POST-CONSULTATION DEBRIEF
PROJECT GHIBERTI

GRANTA PARK | CAMBRIDGE

ABINGTONS PLANNING APPLICATION QUERIES

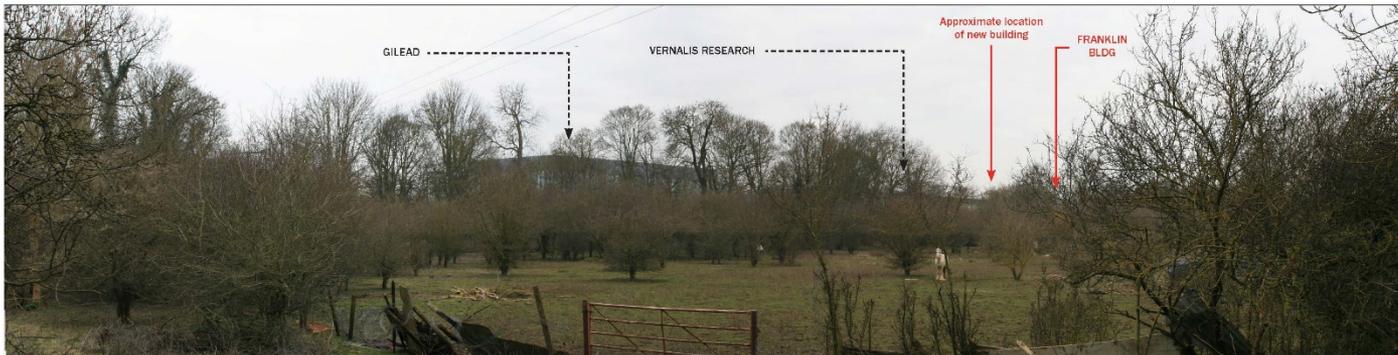
1. Visual Impact of the building during operational phases on Little Abington Village (West Field, Bourn Bridge Cottages, Newmarket Road) has been considered.

-  Site Location
-  Photo Location

Bourn Bridge Photo Location 1: View south west from Bourn Bridge Road.

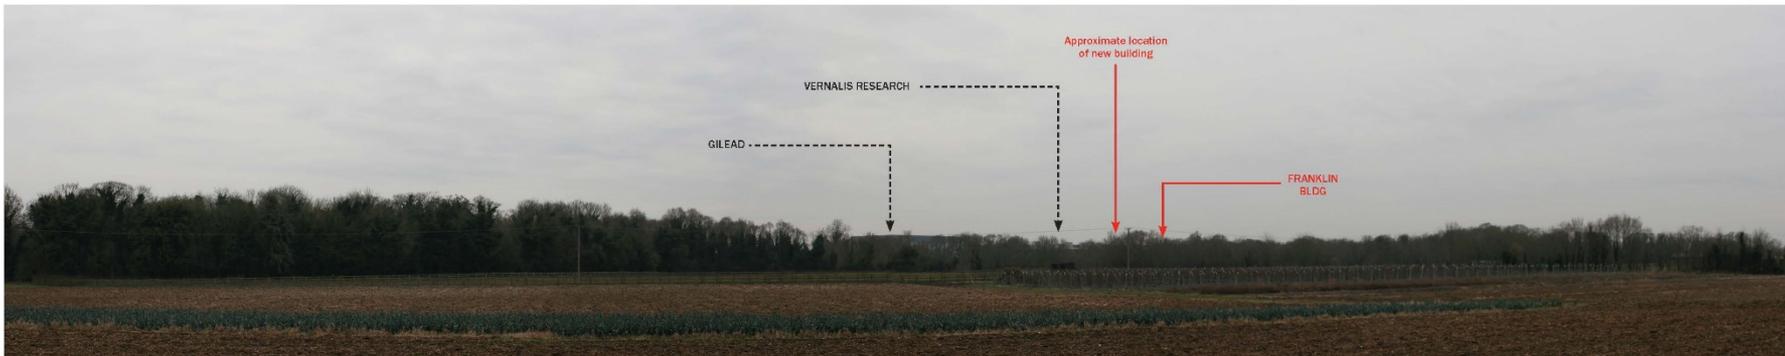
1. Visual Impact of the building during operational phases on Little Abington Village (West Field, Bourn Bridge Cottages, Newmarket Road) has been considered.

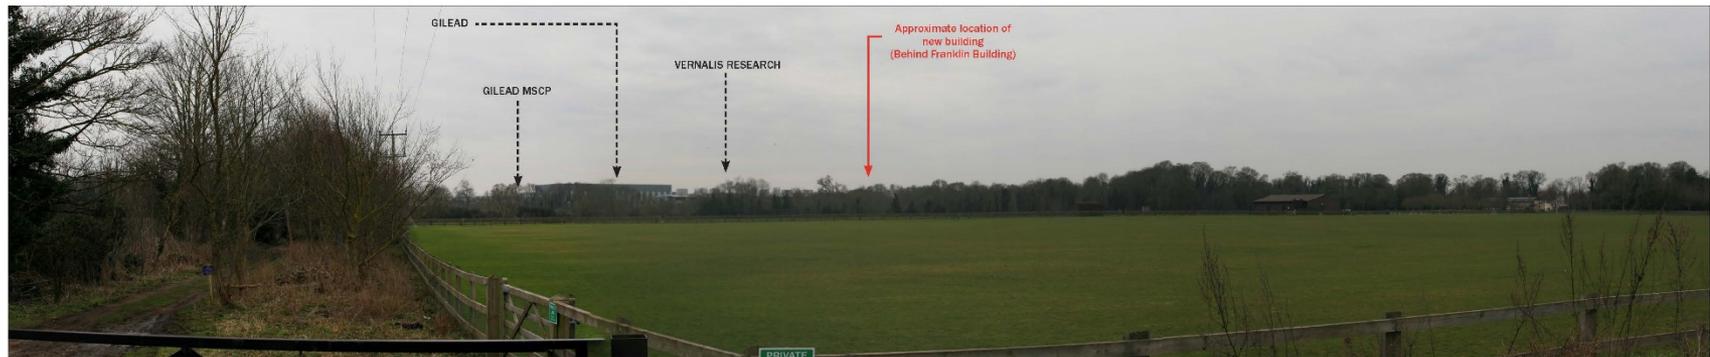
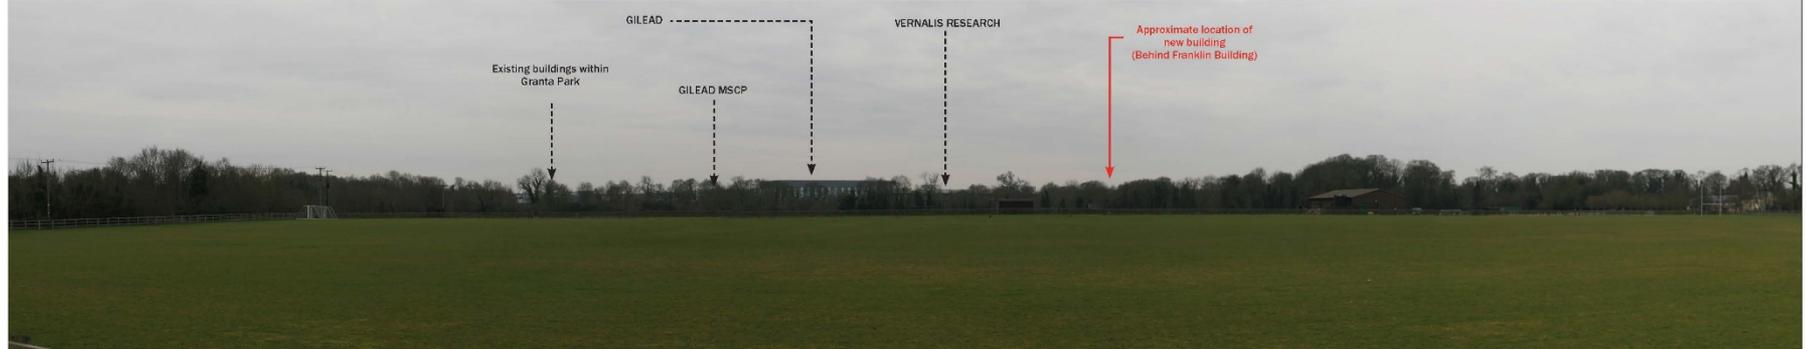
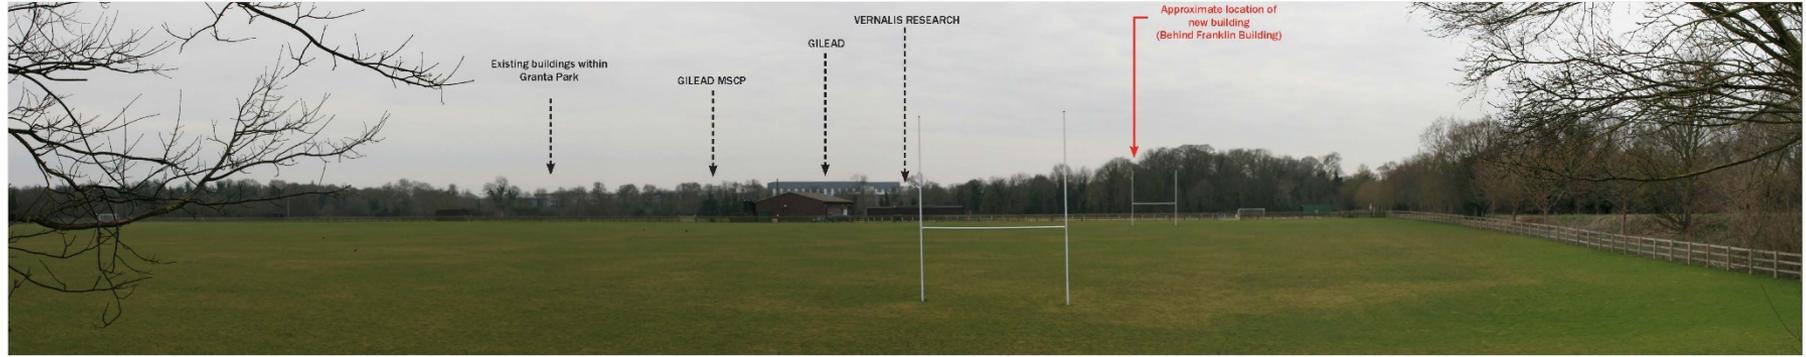
1. Visual Impact of the building during operational phases on Little Abington Village (West Field, Bourn Bridge Cottages, Newmarket Road) has been considered.

Bourn Bridge Road Photo Location 4: View south west from Bourn Bridge Road across the Perse School sports fields.

Bourn Bridge Road Photo Location 5: View south from Bourn Bridge Road across the Perse School sports fields.

Bourn Bridge Road Photo Location 6: View south from Bourn Bridge Road across the Perse School sports fields.

Figure 8.12 Section - Site-1 Building

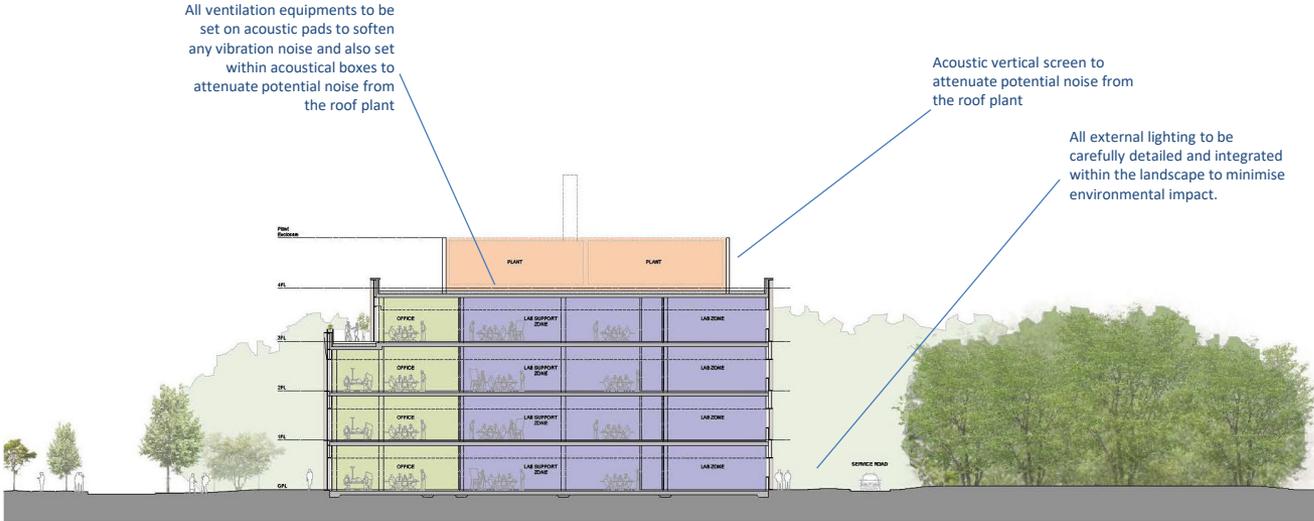
3. Confirm how potential noise and light pollution from the building and car park will be mitigated when the space is operational.

- All Mechanical and Electrical equipment located within the new site including the roof top plant will be selected to minimise noise pollution.
- Where required, noise attenuation measures will be implemented to limit noise from MEP plant to within local restrictions. Acoustic insulation / attenuations provided within the plant equipment
- All roof M&E plant set on Structural base / pads which minimises vibration and adds to further sound transmissions / attenuations.

- The lighting installation are designed to comply with all appropriate standards and industry guidelines, including ILP Guidance Notes for the Reduction of Obtrusive Light GN01/21: 2021 and Local and National Planning Policy.
- External lighting will be carefully detailed and integrated into the architecture and landscape of the scheme to provide safe and secure environments, appropriate to the function and use of each area, whilst minimising obtrusive light.

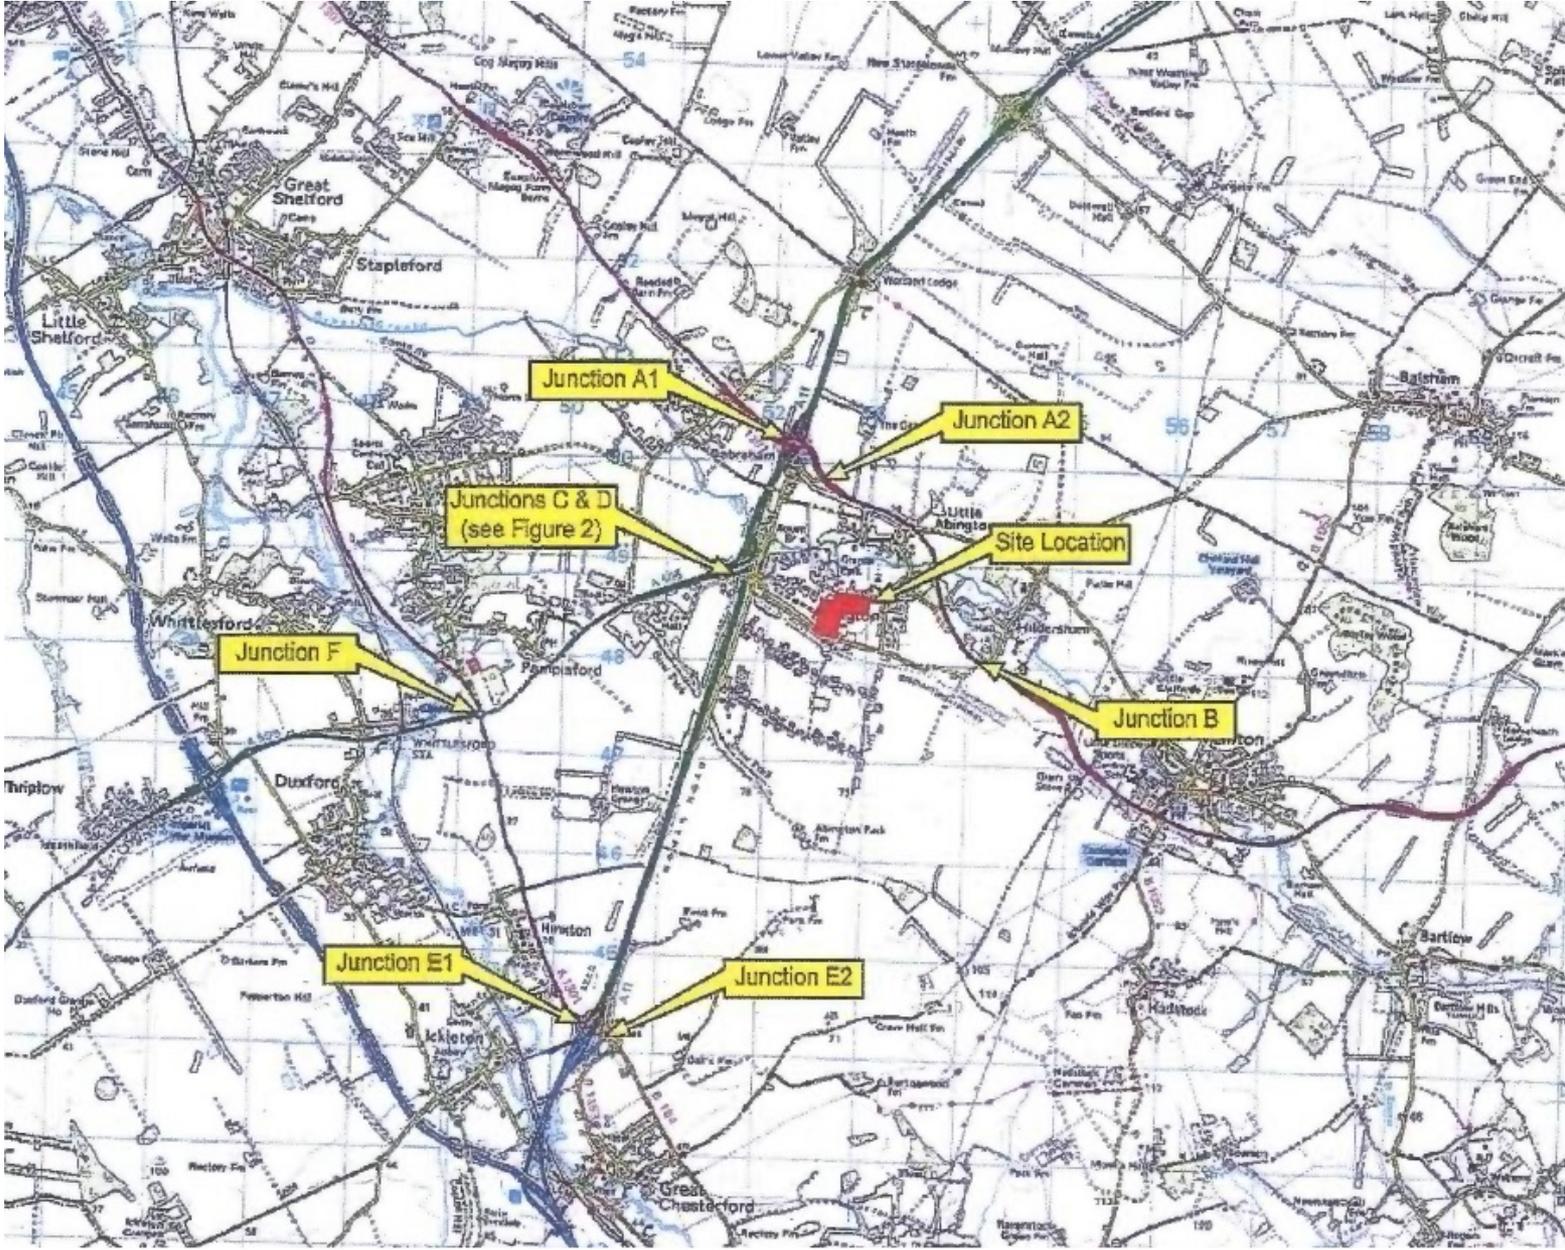
4. Concern raised around increase in traffic volume and associated noise at Granta Park due to operations of new building.

- The capacity of local junctions were assessed where the anticipated percentage increase in traffic flows scenarios is c 5%, a threshold generally acceptable within the Highway authorities.
- The development is compliant with all relevant local and national policies and provides safe and adequate access for all motorised and no-motorised modes of transport.
- Based on this Transport Assessment, it is considered that **the proposed development will not have a significant impact on the operation of the local highway network.**

- **New Access for Site 1** : A new junction in close proximity would impact on the operation of the roundabout and flows on Bourn Bridge. Signalled junction would enable all movements but impact on flows. Consideration required of the existing access arrangements on opposite side of Bourn Bridge. This arrangement will generate additional conflicting movements on the local highway network – potential for increase in accidents and delay on the network with little obvious benefit.

- **Box Junction:** further work could be undertaken to explore the feasibility of a box junction within the existing roundabout, however on initial review it is considered that this may displace the issue to elsewhere within the junction/approach arms and have limited effect. A more detailed review of the proposed junction design and modelling would be required to fully assess the impact of a box junction. The local Highway Authority would also need to agree to any changes to the junction layout.

Fig. 2 Designated Building Zones

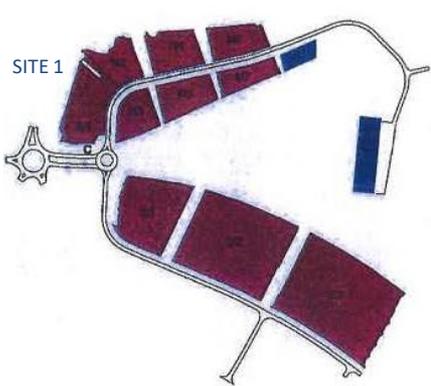
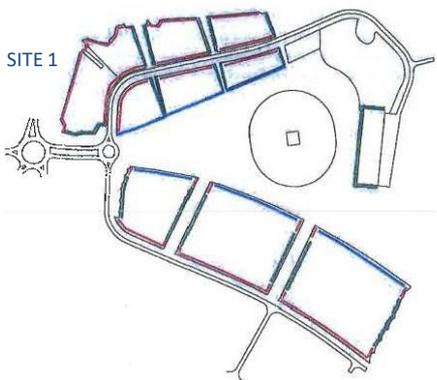
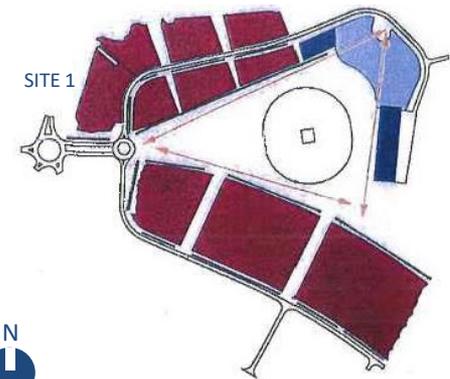
6. Confirm that development is compliant with wider Grant Park master plan

- Siting restricted to building zones identified on the Masterplan.
- Building set backs – 0m at entrance zone and 7m along the ring road.
- Variety of building sizes and configurations allowed.

- Two distinct character areas North and South with a Central Parkland.
- Dedicated building zones for TWI and the Amenity Building.
- Prime Sight Lines – Primary Entrance and the balancing (help preserve important views and sightlines).

- Primary building frontages overlooking central parkland & Secondary building frontages along the North & South access road.
- Buildings – maximise the potential of the site –location, orientation, efficiency and environmental aspects.

- Location of parking, services and storage should take into account prime site lines.
- Building heights – greater heights may be acceptable where it becomes appropriate to vary the silhouette or provide key landmark features.

BUILDING HEIGHT – RECENTLY BUILT AT GRANTA PARK

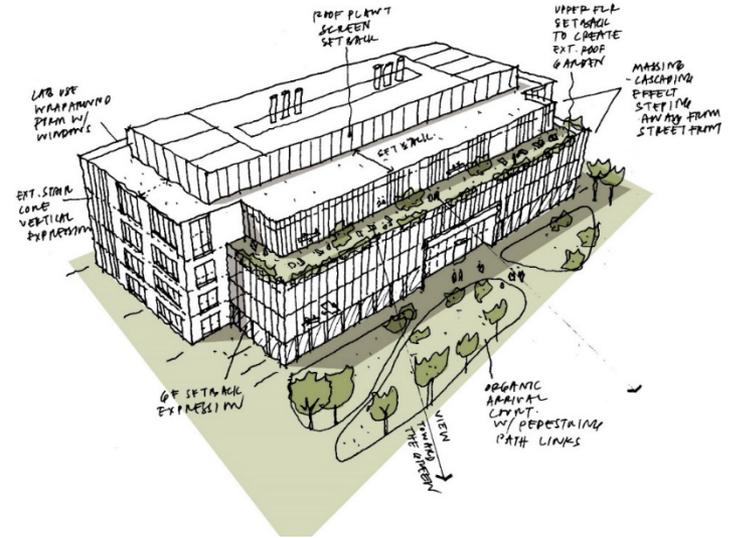
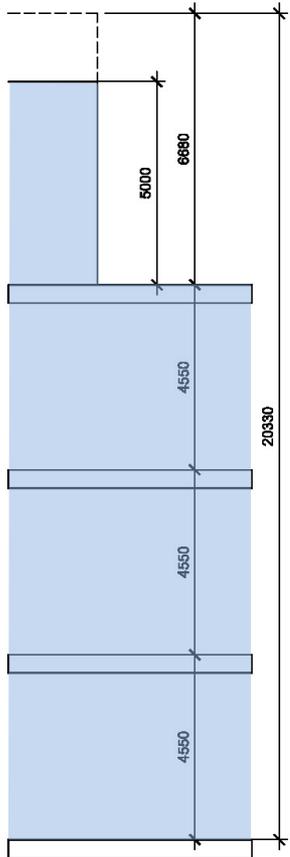
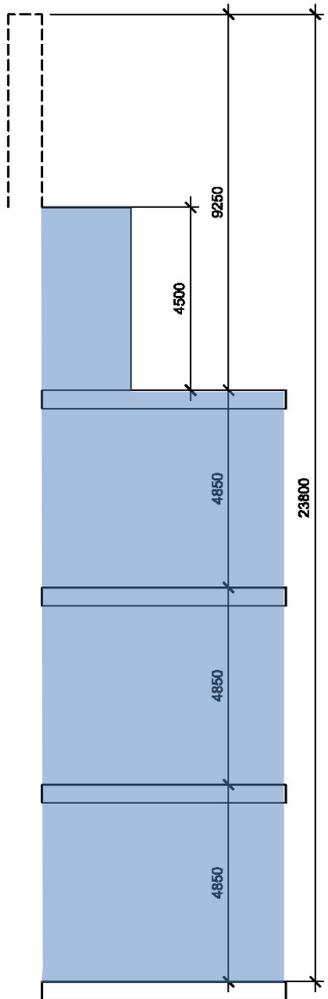
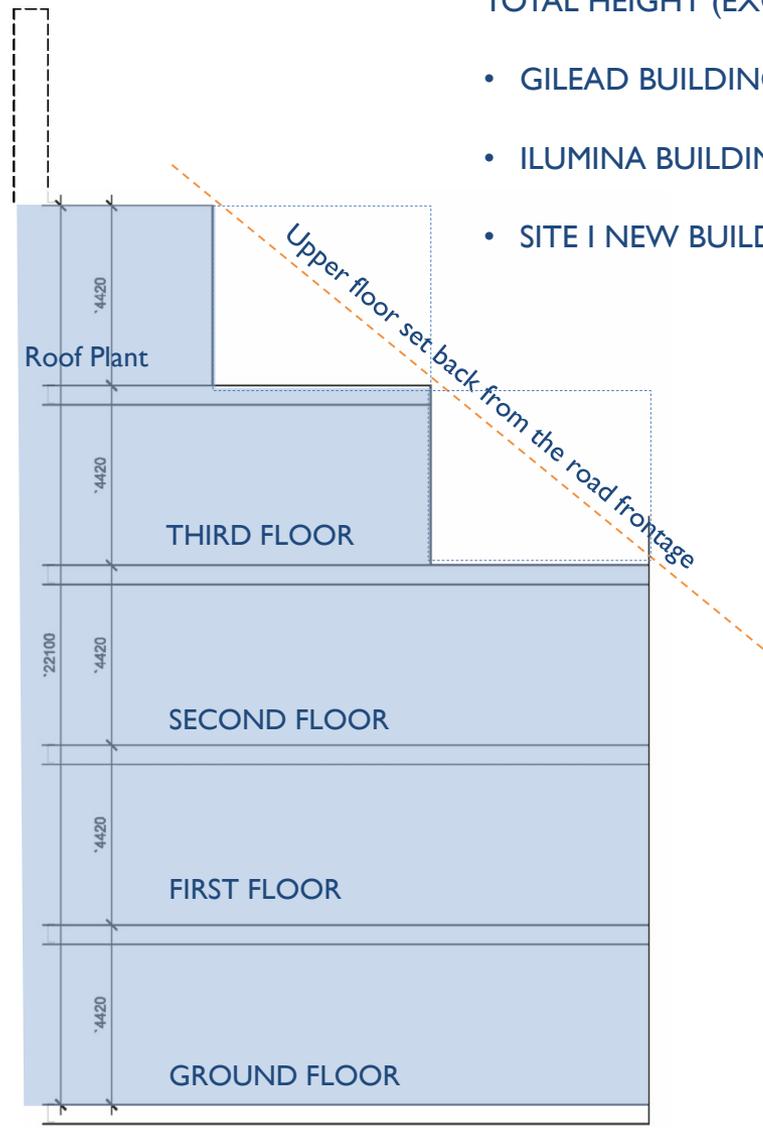
6. Confirm that development is compliant with wider Grant Park master plan

- New proposal creates a cohesive environment help enclose / define the Central Green and is complementary to the park settings.

- GILEAD BUILDING – 18.50 M
- ILLUMINA BUILDING – 19.05 M
- SITE I NEW BUILDING – 22.10 M
